Oak Dam Underground Access Project

**Retention Lease Proposal and
Miscellaneous Purposes Licence
Management Plans
Response Document**

July 2024

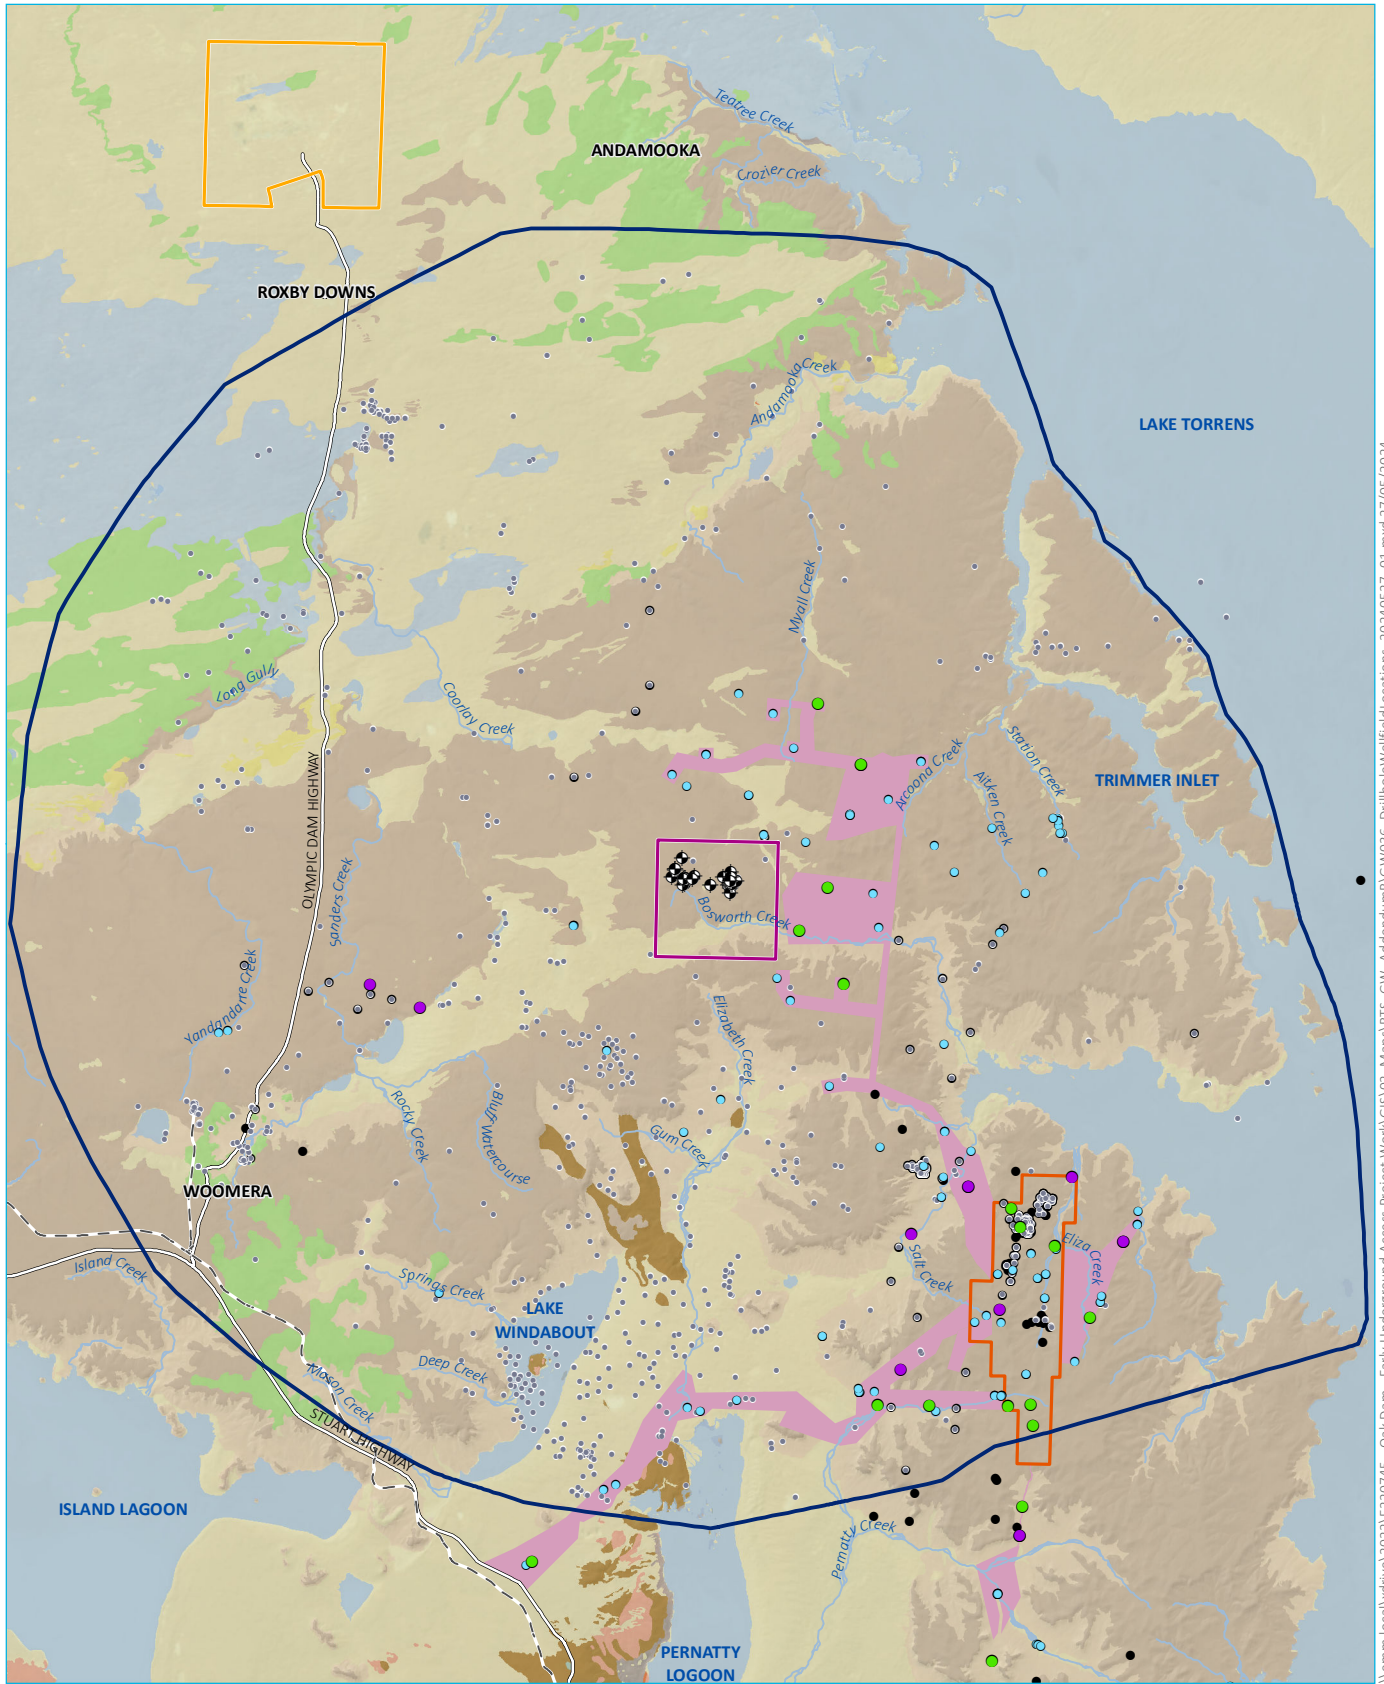
ID	RLP reference	Submission comment	Response/action required from BHP	BHP response	Further detail
58	Vol 1, Figure 1.1	The location of the Carrapateena Mine wellfields should be included on this, or a similar map. The wellfields are discussed extensively as a key receptor and therefore their location needs to be provided.	Provide an updated Figure 1.1 (or similar) which includes the location of the Carrapateena Mine wellfields.	Agreed – MPL 156 production bores are included in Appendix B, comprising location and Northern Wellfield production bore details.	PRD Appendix B, Figure 3.1, Table 3.2
60	Vol 1, Figure 3.10	Groundwater bores provided in this figure require label identifiers.	Provide an updated version of Figure 3.10 which includes labels for all bores.	Agreed – MPL 156 production bores are included in Appendix B, comprising location and Northern Wellfield production bore details.	PRD Appendix B, Figure 3.1, Table 3.2

75	Vol 3, C4, Figure 2.1	The Carrapateena production bores are not shown on the figure.	Provide an updated figure which includes the Carrapateena production bores.	Agreed – Refer to response to comment ID 58.	PRD Appendix B, Figure 3.1, Table 3.2
79	Vol 3, C4, Table 2.2	A figure needs to be provided to show how rainfall and evaporation (or ET) vary through the year. The model suggests a recharge rate of 0.1 to 0.4 mm/yr., and this needs to be supported.	Please provide a figure as requested.	Noted – A rainfall and evaporation/ET over time figure will be provided as part of the PEPR.	N/A

Figure 3.11

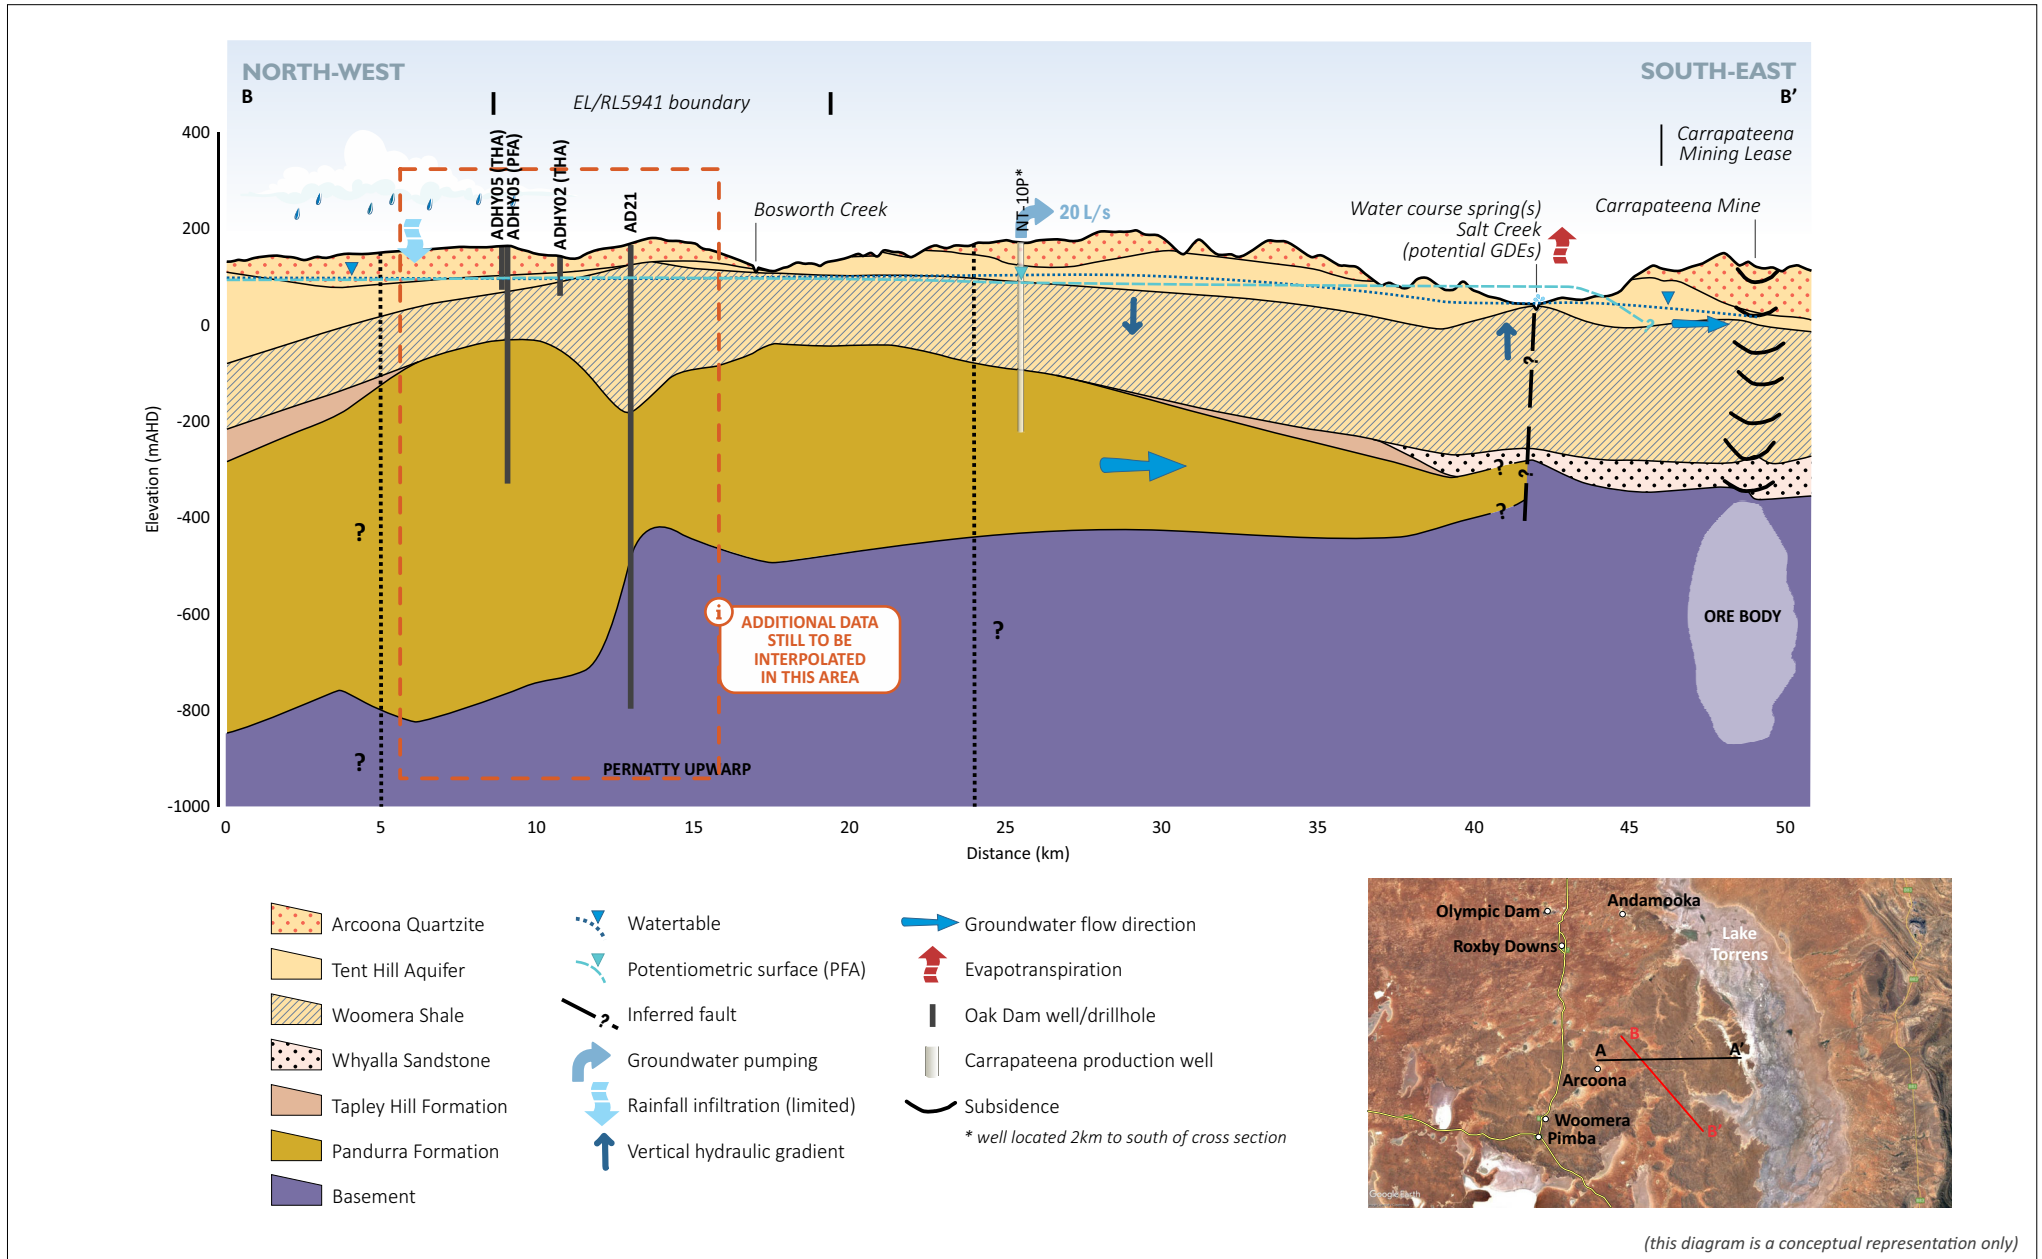
ID	RLP reference	Submission comment	Response/action required from BHP	BHP response	Further detail
30	C4, 2.1.2	<i>The wellfields total 16 production bores (CDM Smith 2018), and their locations as of 2018 are shown in Figure 2.1.</i> The position of the wellfields is important because of the proximity to OKDUGA. They are <u>not</u> shown in Figure 2.1. The text refers to 16 wells, Table 2.1 shows 12, Figure 2.1 shows none.	Provide an updated and corrected figure: Include the wellfield locations to ensure consistency between text, table and figure.	Agreed – MPL 156 production bores are included in Appendix B, comprising location and Northern Wellfield production bore details.	PRD Appendix B, Figure 3.1, Table 3.2
31	C4, 2.1.2 C4, 2.3, Attach A	<i>Fracturing occurs mostly within the Pandurra Formation, only four exploration holes recorded observations of fracturing across the Tent Hill Formation.</i> Please refer to Comment 18. The statement above appears to contradict (or at least does not support) the fractured nature of the Lower Arcoona Quartzite in the proposal and Table 2.4 in C4.	Provide updated and corrected text to ensure consistency.	Noted – The hydrogeological conceptual model cross sections have been updated using additional site data to show the PFA, Tapley Hill Formation and Whyalla Sandstone. Additional text clarifying the role of the Upper and Lower Arcoona Quartzite added to Appendix B, specifically the THA comprises the lower white Arcoona Quartzite and Corraberra Sandstone. Additional drilling investigations are proposed in the PRD forward works plan and will be further updated as part of the PEPR.	PRD Appendix B, Section 3.9, Table 3.1, Figure 3.10, Figure 3.11

82	Vol 3, C4, 2.2.2	Hydrographs from the Carrapateena bores should be provided where they are available.	Provide available hydrographs Carrapateena bores.	Agreed – Site specific hydrographs, from the OKDUGA Project are provided in Appendix B.	PRD Appendix B, Figure 3.6
83	Vol 3, C4, Figure 2.12, Figure 2.13	These figures strongly suggest that density corrected heads need to be developed and used in conceptual model development.	Provide density corrected heads.	Agreed – Density corrected groundwater elevations have been recreated in Appendix B using additional site data and reference to existing literature.	PRD Appendix B, Section 3.4.1, Figure 3.4, Figure 3.5
84	Vol 3, C4, Figure 2.14 Vol 3, C4 Attach A, Figure 2.8	<i>Conceptual hydrogeological cross section</i> Whilst DEW acknowledge that the cross section is meant to be a conceptual representation only, based on current geological knowledge and presented potentiometric surfaces, there appears to be sufficient information to more accurately depict water levels than what is indicated. This would be helpful in determining where the THA is either confined or unconfined (and therefore representative of the water table) and to confirm conceptual relationships between groundwater pressures in the THA and LSP aquifers.	Provide or describe the source of information used to generate the geological cross section conceptual model. Where necessary provide updated cross sections with redrawn groundwater level information that is reflective of potentiometric surface interpretation and data source.	Agreed – The hydrogeological conceptual model cross sections have been updated in Appendix B, reflecting amendments to potentiometric surfaces. In addition, a new figure has been prepared showing the data points used to inform the cross section.	PRD Appendix B, Section 3.9, Figure 3.10, Figure 3.11

Figure 2.1 Year 2 water balance (Operations Part A) (Average of all model realisations)

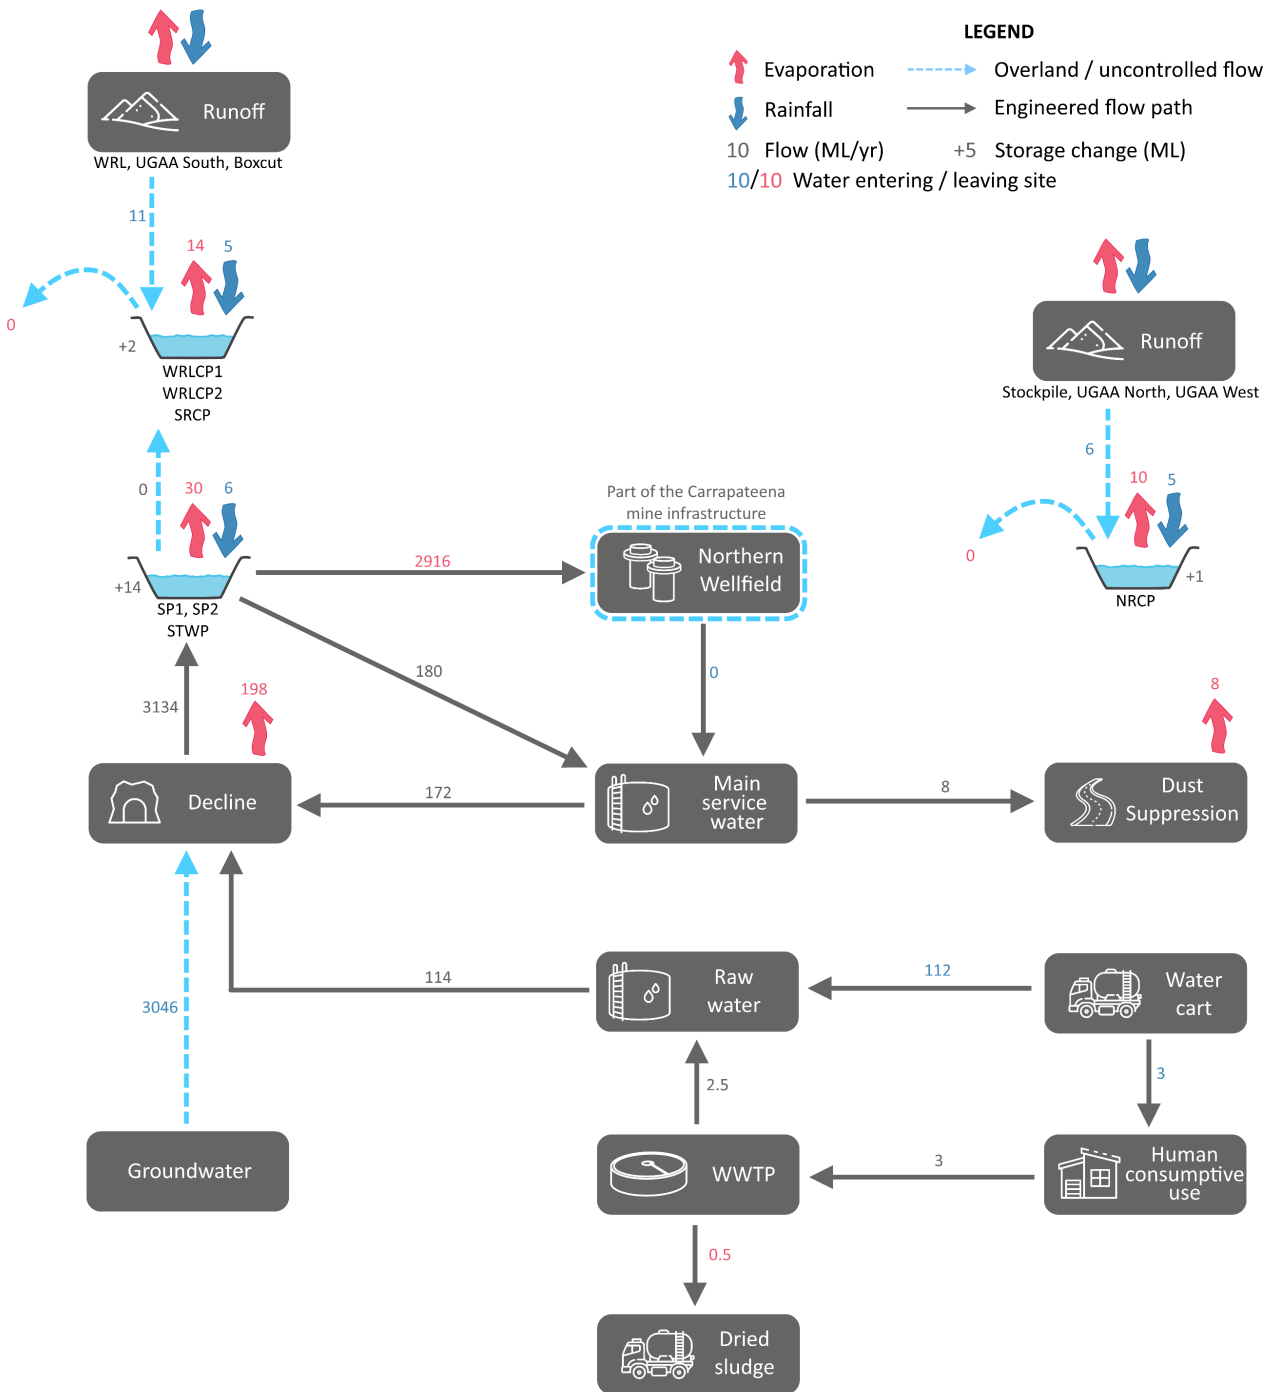
ID	RLP reference	Submission comment	Response/action required from BHP	BHP response	Further detail
68	Vol 1, Figure 4.26	<p>The following matters regarding this figure and subsequently the water balance of operations require further elaboration.</p> <ol style="list-style-type: none"> 1. There is no volume allocated for dust suppression in years 1-2 2. There is a line between human consumption and seepage disposal connecting to portal and decline that appears to have no volume attached in either figure – discuss whether this line is meaningful 3. The sum of inputs for the settled water dam in years 1-2 is 223 ML/y, whereas outputs appear to be 153 ML/y. Clarify whether this is correct. If so, where does the 70 ML/y difference end up. 4. Whilst the above imbalance is the largest noted, there are other minor imbalances noted of up to 16 ML/d. Please check the figure for inaccuracies and correct if required. 	<p>Provide the requested information and if necessary, provide an updated Figure showing the site-wide water balance model.</p>	<p>Agreed – Water balance updated and includes dust suppression volumes during construction and operation (Appendix D).</p>	<p>PRD Appendix D, Figure 2.1 and Figure 2.2</p>
